# TECHNICAL SERVICE BULLETIN

**BULLETIN NUMBER: DOBJ/DOBK – 022 REISSUE ★**

**LANIER – IM C2000/IM C2500**

**SUBJECT: TROUBLESHOOTING: SC860 THRU 865, 869, 870, 872, 873, 874, 876**

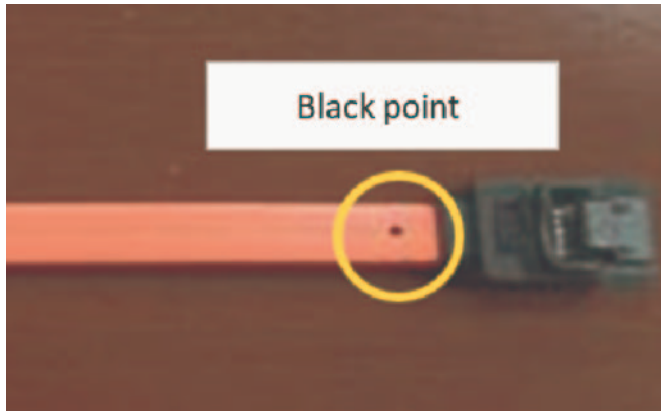
The HDD Cable provided from the vendor  
(P/N: D2415250: Cable: HDD: SATA:210) is defective.

The HDD Cable has been modified since July 2019 production.

- ★ The Black Dot (Point) as shown in the photo below, indicates the new style cable.

1. Replace the HDD cable when SC8XX occurs.
2. If the symptom still occurs, replace the HDD or other parts (see Service Manual for procedure).
